DESCRIPTION: Applicant Groundswell Conservancy proposes to combine two existing parcels via certified survey map (CSM), to create one 12.8-acre residential lot zoned RR-8. They will also establish a building envelope, and conservation easement for non-buildable areas.

DNR wetlands and FEMA floodplain:

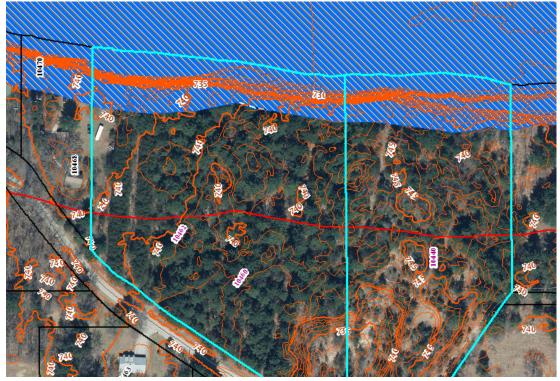
OBSERVATIONS: The site is characterized by its frontage on the Wisconsin River, significant tree cover, and steep topography along the river bank where the elevation drops from 743 feet to 727 feet above sea level. The north end of the property contains DNR-mapped wetlands, FEMA floodplain and Zone AE floodway, and is subject to shoreland zoning within 300 feet of the ordinary high water mark of the river (see images below). The mapped wetlands in this area appear to be confined to the floodplain shelf, and the remainder of the site does not contain wetland indicators.

The applicants have identified a proposed building envelope for a new home near the center of the site, in a location that appears to be outside of the floodplain and 75-foot wetland setback. The base flood elevation on this site is 738 feet above mean sea level; the entire proposed building envelope appears to be located above this elevation. The building envelope would be partially within the 300-foot shoreland zoning district; lands in this area are subject to impervious surface limits. If the impervious surface ratio exceeds 15%, shoreland mitigation will be required.
